Quantization Noise Feature in COM Matlab Code

COM Commit Request Number 4p6_5

**Hossein Shakiba
Huawei Technologies Canada
October 2024**

Example Outputs

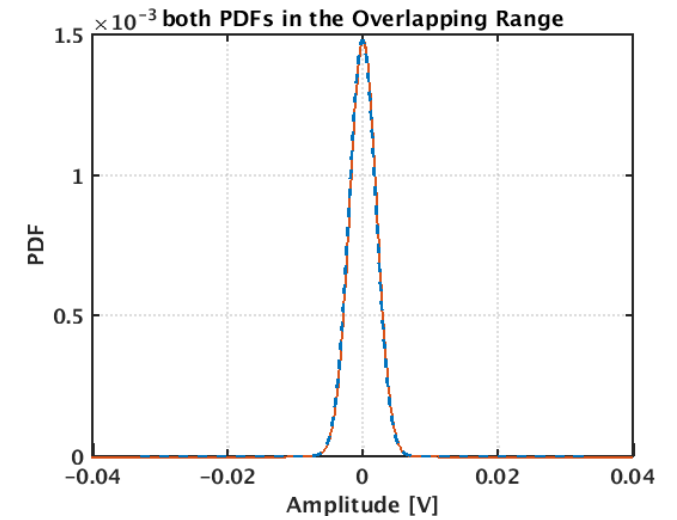
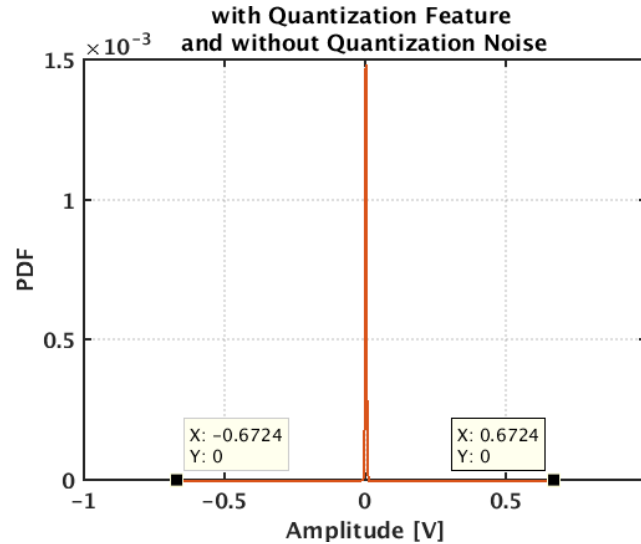
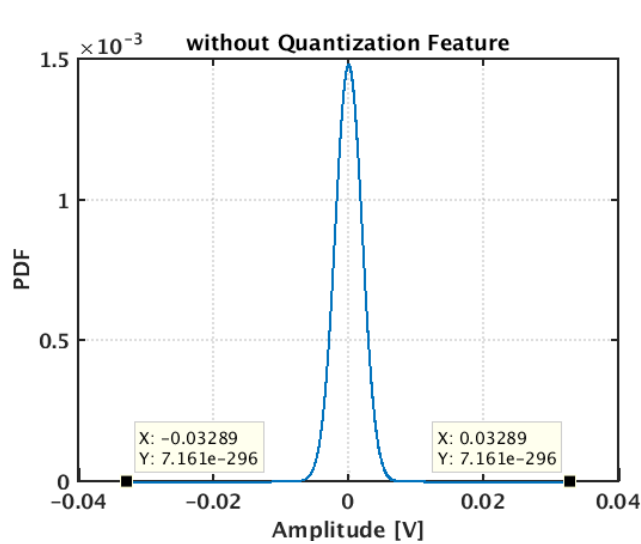
Before Change	After Change
Without Quantization (Default)	<p>Com_ieee8023_93a_470beta1 (N_tc = 128)</p> <p>DER_MLSE_trunc: 2.0764e-06 Q_budget_adj: 0 COM_from_matlab: -0.7246</p>	<p>Com_ieee8023_93a_470beta1_quant (ENOB = 32)</p> <p>DER_MLSE_trunc: 2.0764e-06 Q_budget_adj: 0 COM_from_matlab: -0.7246 DER_MLSE: 2.0764e-06 DER_DFE: 1.4608e-04 COM: 1.0876 delta_com: 1.8122</p>
With Quantization (ENOB of 6)	<p>DER_MLSE: 2.0764e-06 DER_DFE: 1.4827e-04 COM: 1.0876 delta_com: 1.8122</p>	<p>Com_ieee8023_93a_470beta1_quant (ENOB = 6)</p> <p>DER_MLSE_trunc: 3.0762e-05 Q_budget_adj: 0 COM_from_matlab: -1.6987 DER_MLSE: 3.0762e-05 DER_DFE: 6.6515e-04 COM: -0.1006 delta_com: 1.5981</p>

- It is recommended that this change be made along with the change for MLSE truncation
- There is a negligible difference in DER_DFE (see the backup slide)
